REMARKS/ARGUMENTS

In sections 4-8, the drawings were objected to because of various informalities. In response, the specification is being amended above to add various reference characters shown in Figure 4. The elements, "defined timer", NLPs, IDLE, T_pulse, signal detector, and reset signal generator, are also being removed from the claims, in response to the drawing objections. No new matter is being added by the correction to the drawings and amendment to the specification. For the above reasons, Applicant requests

FIGURE 3

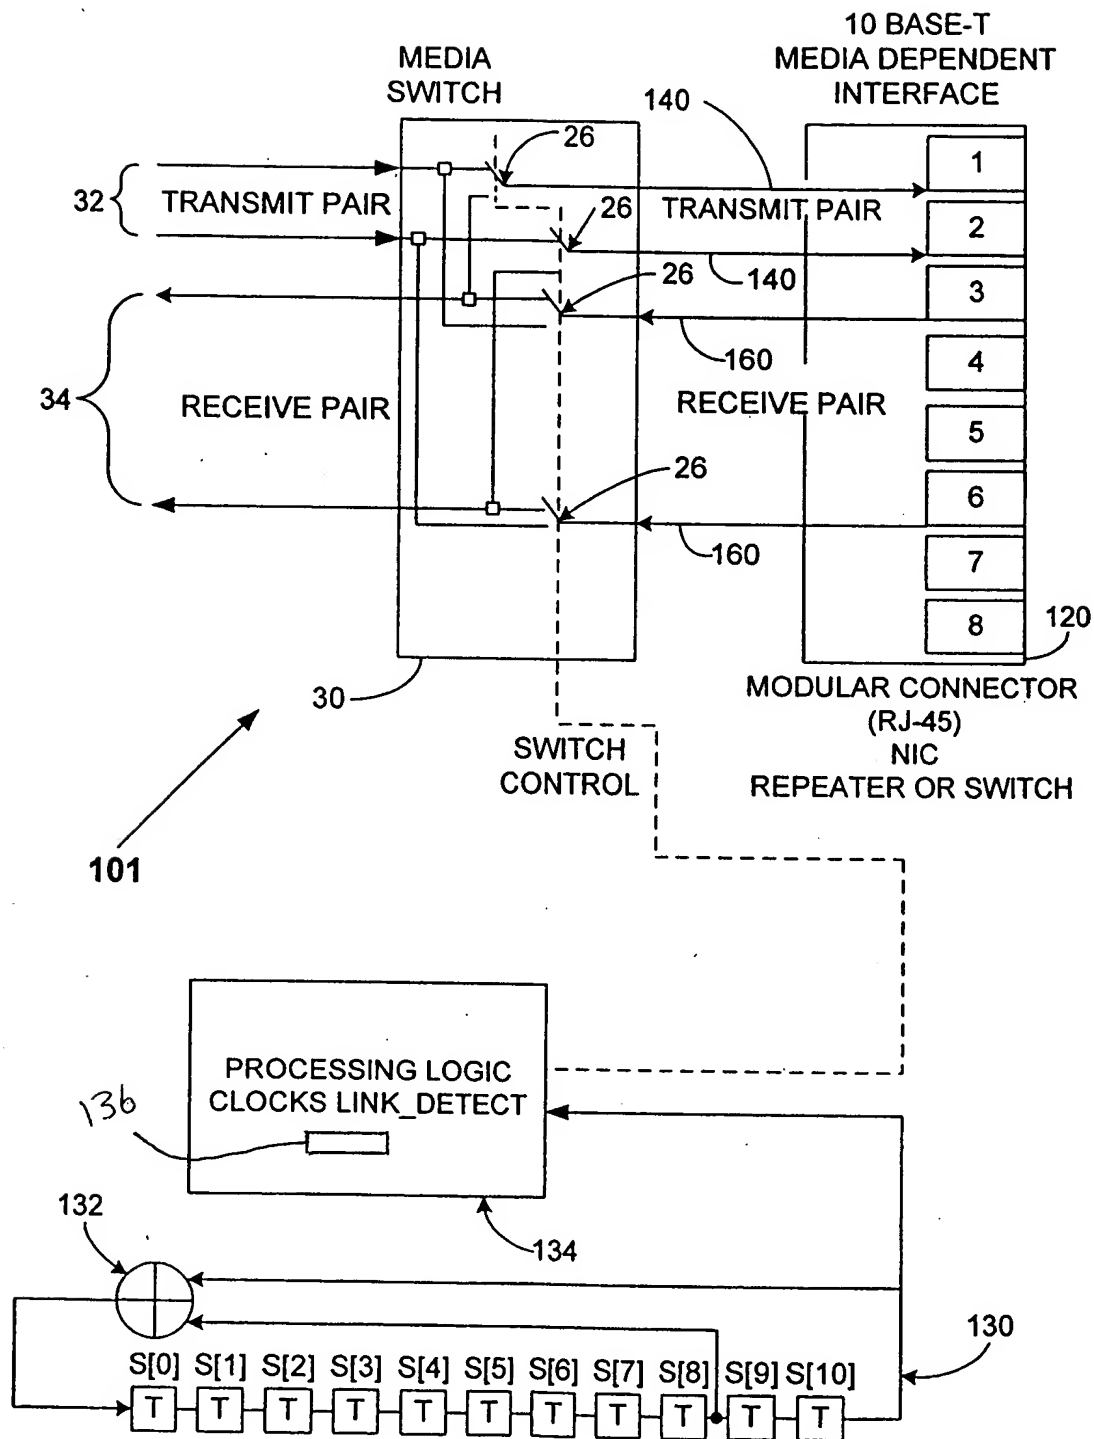
In section 9 of the office action, the drawings were objected to under 37 CFR. 1.83(b) because the drawings are allegedly incomplete. The Examiner states that the current drawings do not show "signal detectors", "timers and reset", "link detect", and "force hold" as disclosed in the specification. In response to the drawing objections, Figure 3 is being amended to show the signal detector 136 which is also a timer which acts to reset the state machine (which is typically in the processor 134 or implemented as the processor 134), as stated in page 11, line 10 in the originally filed specification. It is also respectfully asserted that the element "reset" is shown on Figure 5 as the PMA_RESET signal and is discussed on page 12, lines 7-10 of the filed specification. The element "link detect" is shown on Figure 5 as "LINK_DET" and can have "true" or "false" values as represented in Figure 5 by the arrows 240, 244, 255, 245, 248, 250, and 270. The element "force hold" is shown on Figure 5 as "FORCED_HOLD" and can have "true" or "false" values as represented in Figure 5 by the arrow 240. FORCED_HOLD is also shown in blocks 242, 246, and 280. Accordingly, the elements "reset", "link detect", and "force hold" are shown in the drawings. Figure 5 is being clarified to indicate that the element "reset" is PMA_RESET signal, the element "link detect" is "LINK_DET", and the element "force hold" is "FORCED_HOLD", consistent with the discussion in the filed specification.
